Refer to: HSA-10/WZ-125

Thank you for your letter of March 29, 2002, and facsimile message of November 21, 2002, requesting Federal Highway Administration (FHWA) acceptance of your company's portable sign stands as crashworthy traffic control devices for use in work zones on the National Highway System (NHS). Accompanying your letter was a report of crash testing conducted by the Midwest Roadside Safety Facility. You requested that we find these devices acceptable for use on the NHS under the provisions of National Cooperative Highway Research Program (NCHRP) Report 350 "Recommended Procedures for the Safety Performance Evaluation of Highway Features." Most of the sign support systems that were tested in this phase were reviewed previously and are the subject of our November 21, 2001, letter to you, designated WZ-99. This present letter of acceptance, WZ-125, will only deal with the one remaining sign stand that was tested with successful results.

Figure 4. System Nos. 58 and 59 Sign Support Details, Test D-30

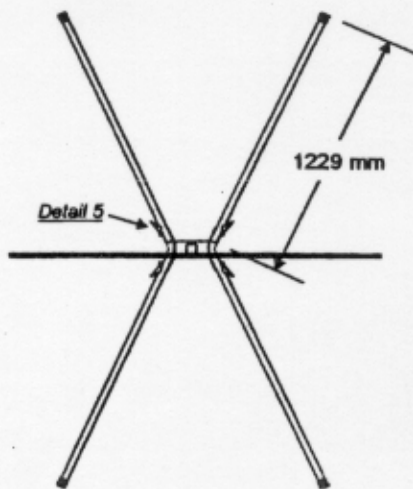
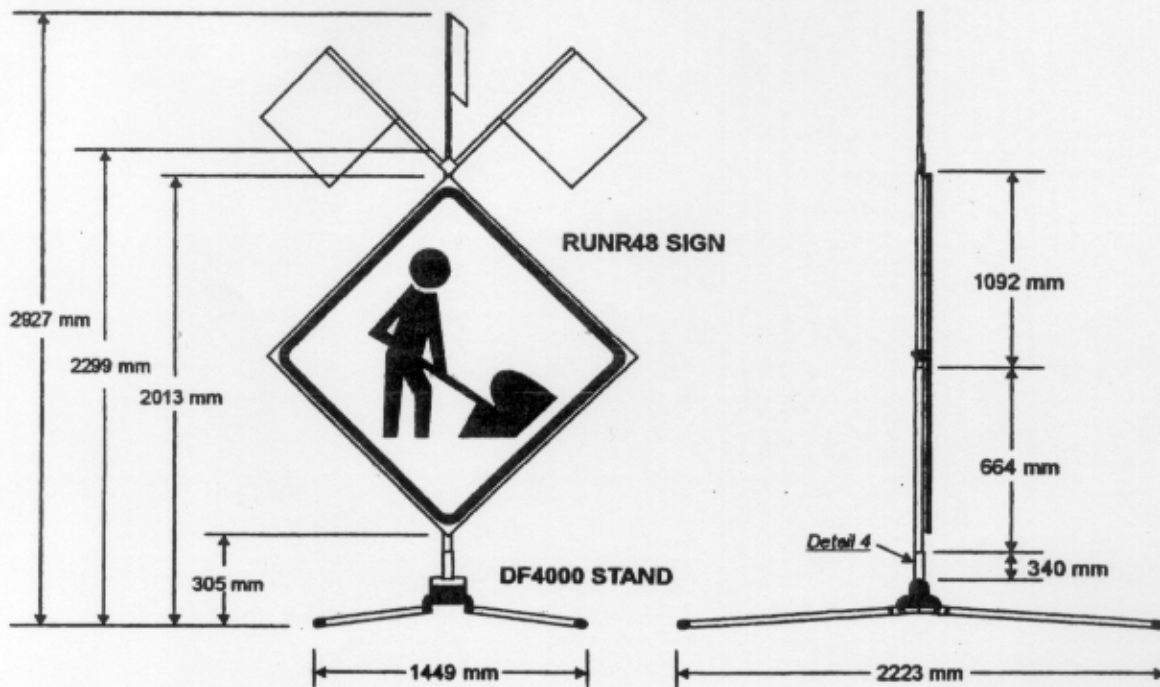
Damage was limited to dents, and minor windshield cracking. The results of the testing met the FHWA requirements and, therefore, the devices described above and shown in the enclosed drawings for reference are acceptable for use on the NHS under the range of conditions tested, when proposed by a State.
